Meeting Date:		December 5, 2024				
Item Name:		Site Plan & Design Review - Tractor Supply Co. - 880 Marketplace Drive				
Originating Department:		Community Development				
Presented by:		Lane Braaten				
Previous Commission Action (if any):						
Item Type (X only one):	Consent		Regular Session	X	Discussion Session

Provide a recommendation to the City Council regarding the Site Plan & Design Review application for the proposed Tractor Supply Company proposed to be located at 880 Marketplace Drive.

The applicant, David Soto, has submitted an application for Site Plan & Design Review to construct a 21,930 square foot Tractor Supply Company building on the subject properties identified above.

SHEET:
SITE DEVELOPMENT PLAN

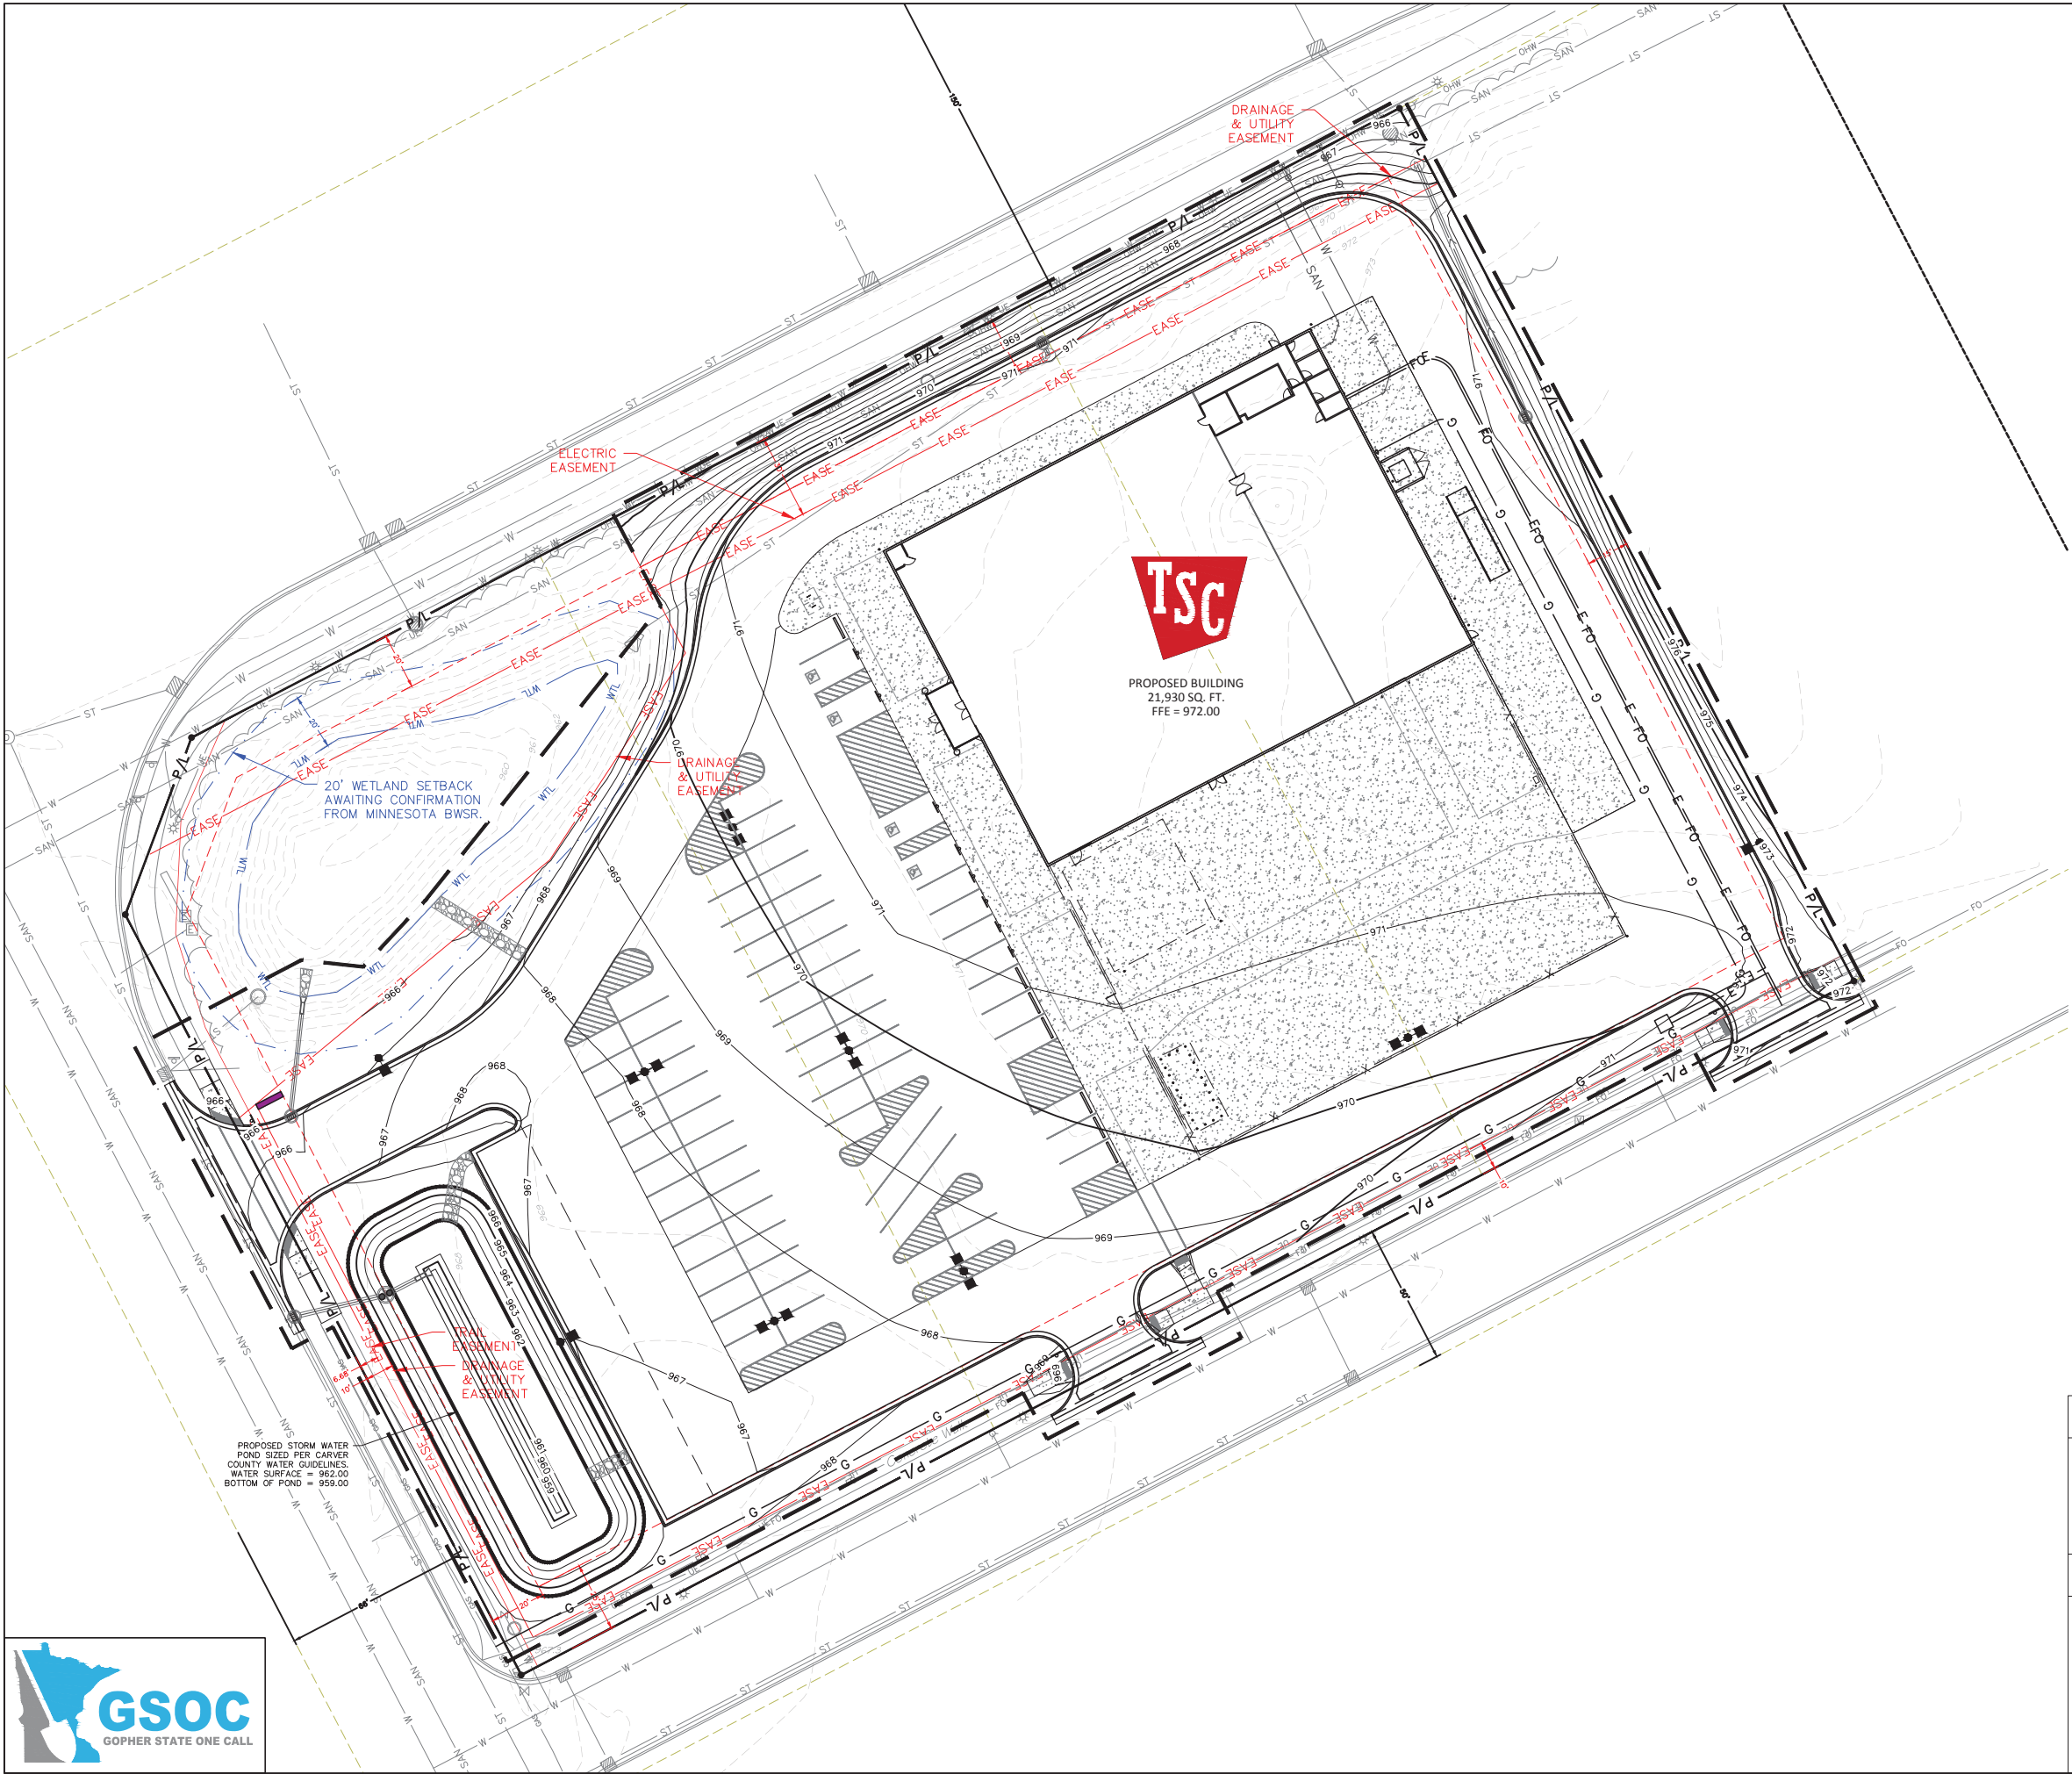
The structure setbacks, building height, and hardcover surface requirements stated above have been satisfied based on a review of the Site Development Plan– C102 dated November 26, 2024 and the Exterior Elevations – A2 dated November 21, 2024.

EXHIBIT J

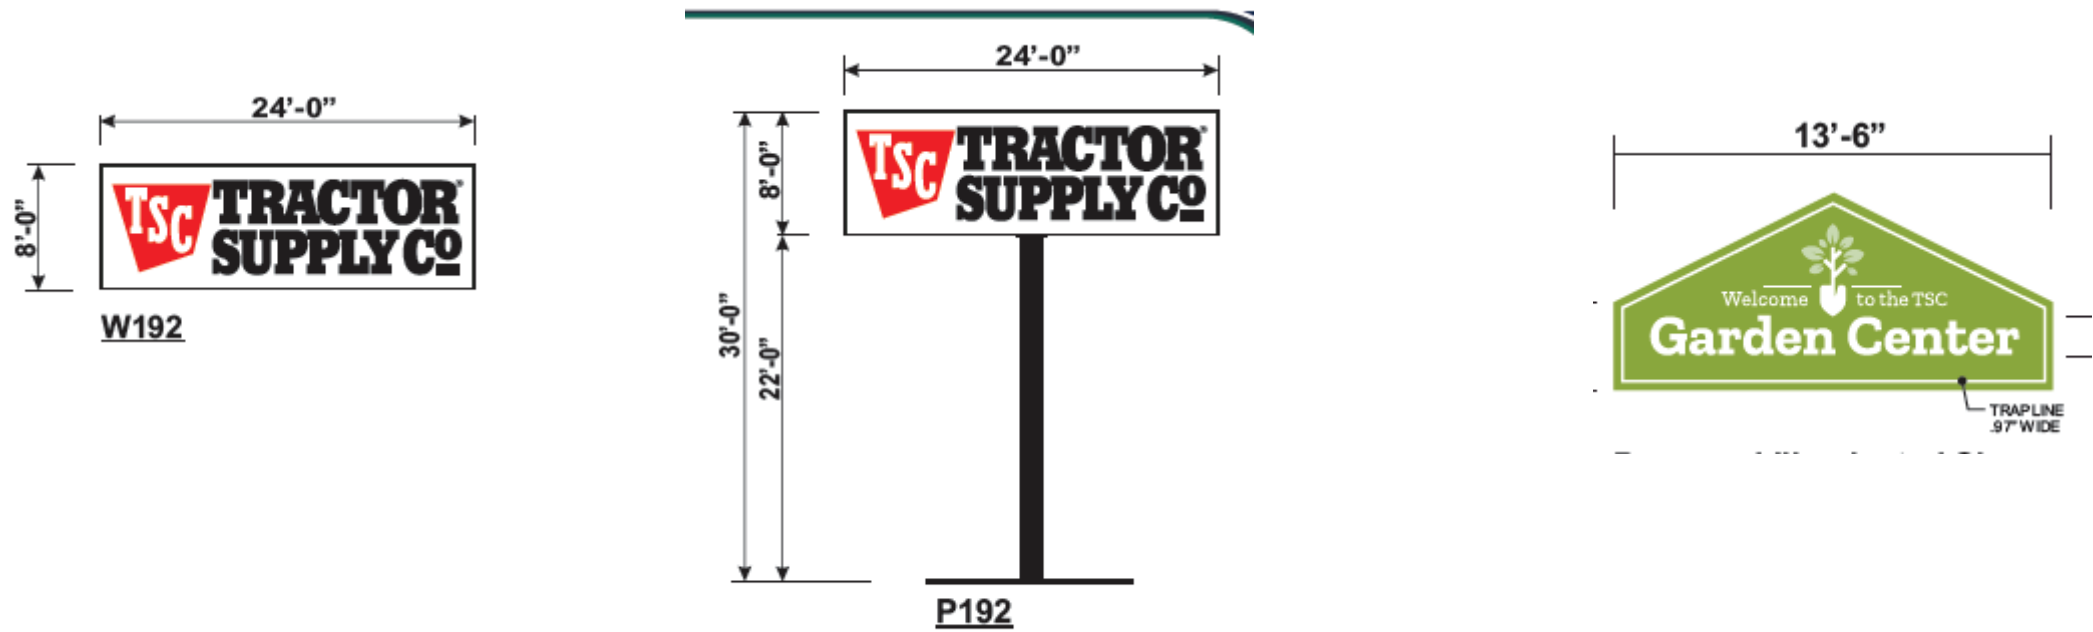
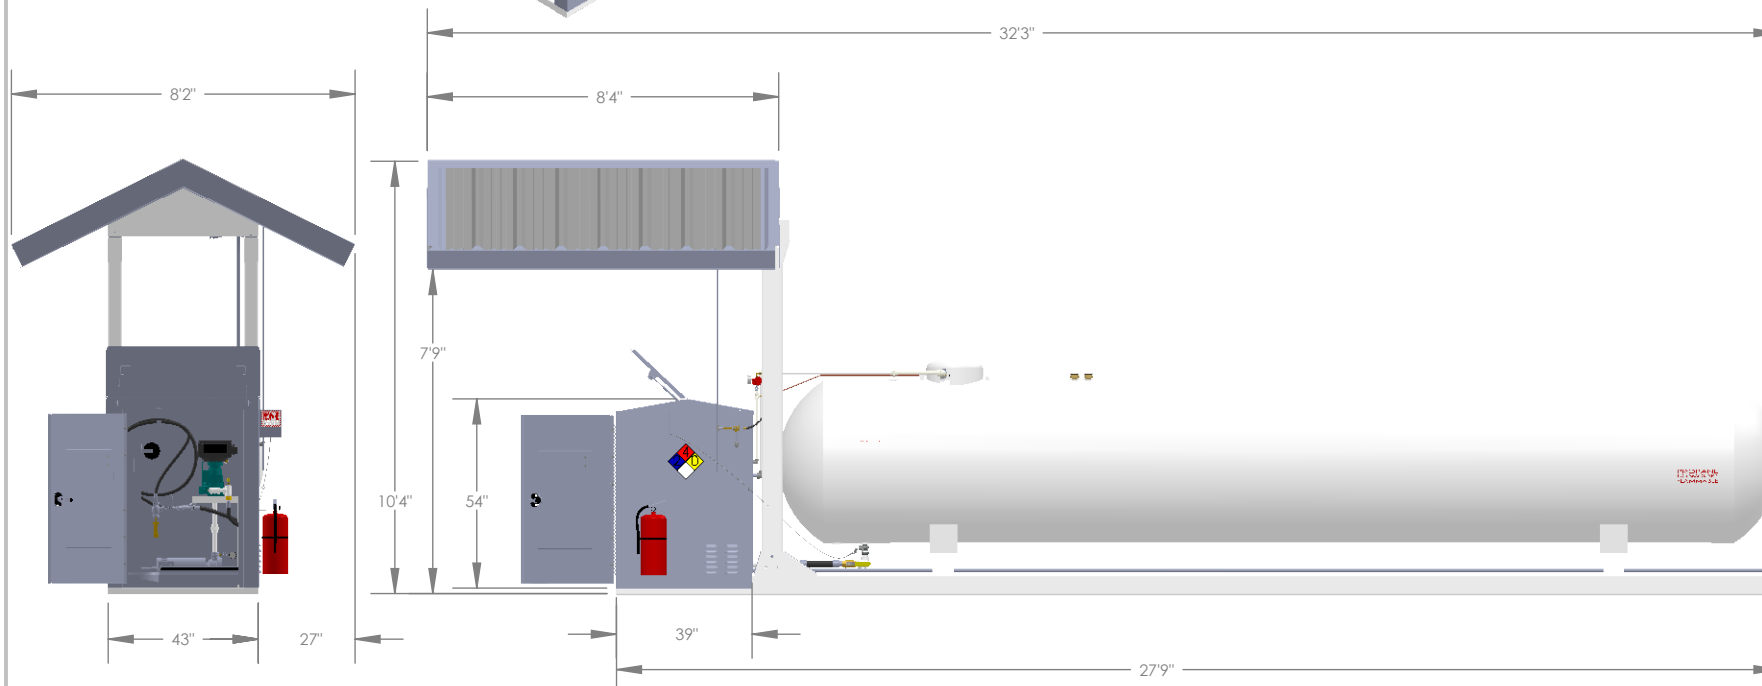
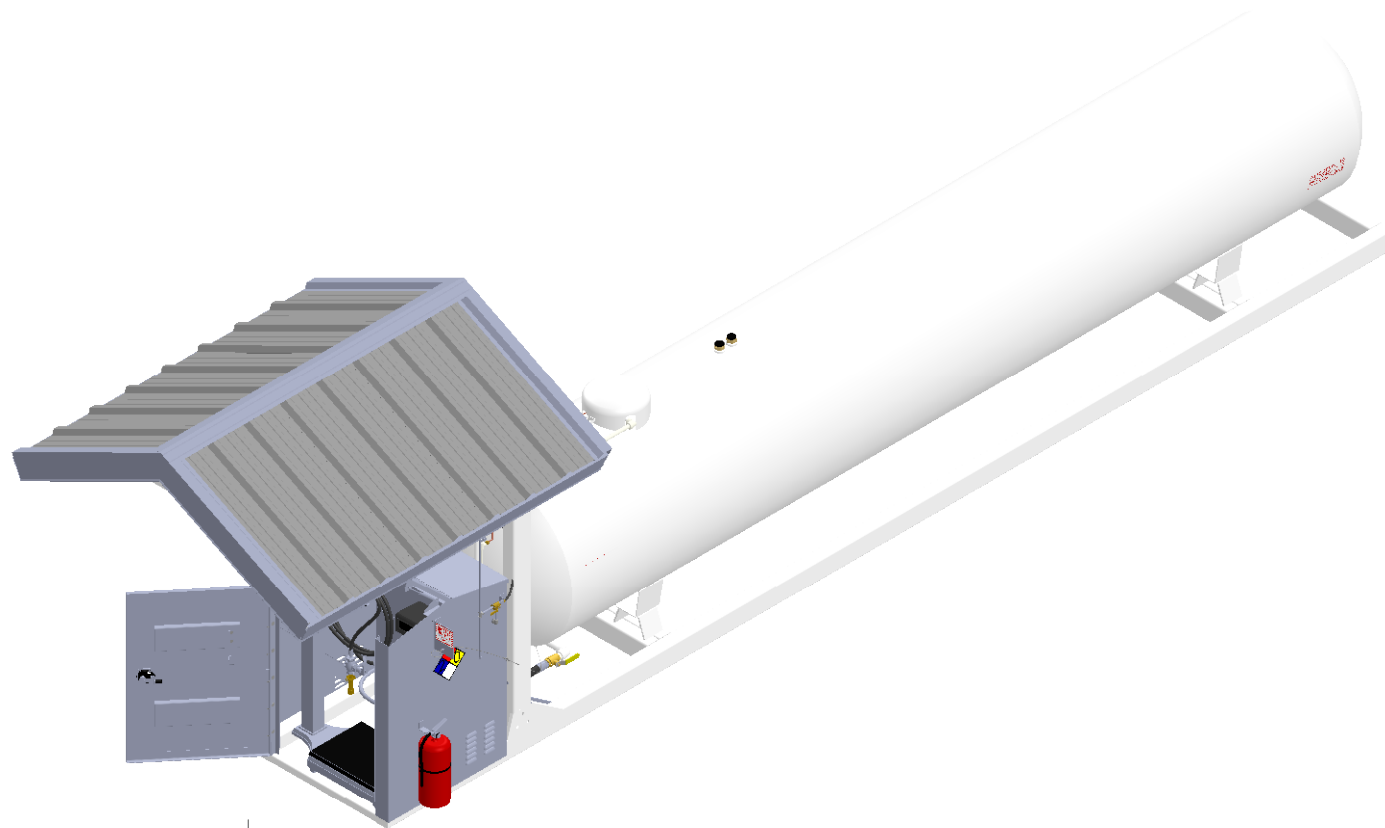
Additionally, wall signs are regulated under 900.10, B-1 and B-4 Districts. Please review the applicable section of the City Code to determine the most appropriate application of the rule. But, in summary, one wall sign covering a maximum of 10% for the building face is allowed. The current plan indicates two (2) signs on the front face including the tractor supply sign and the garden center sign. The plan needs to be revised accordingly.

7. A sign permit shall be required for all signage and shall conform to Section 900.10.
8. The applicant shall combine the three parcels into one (1) parcel via an application with Carver County and provide documentation that this has been completed prior to building permit issuance.
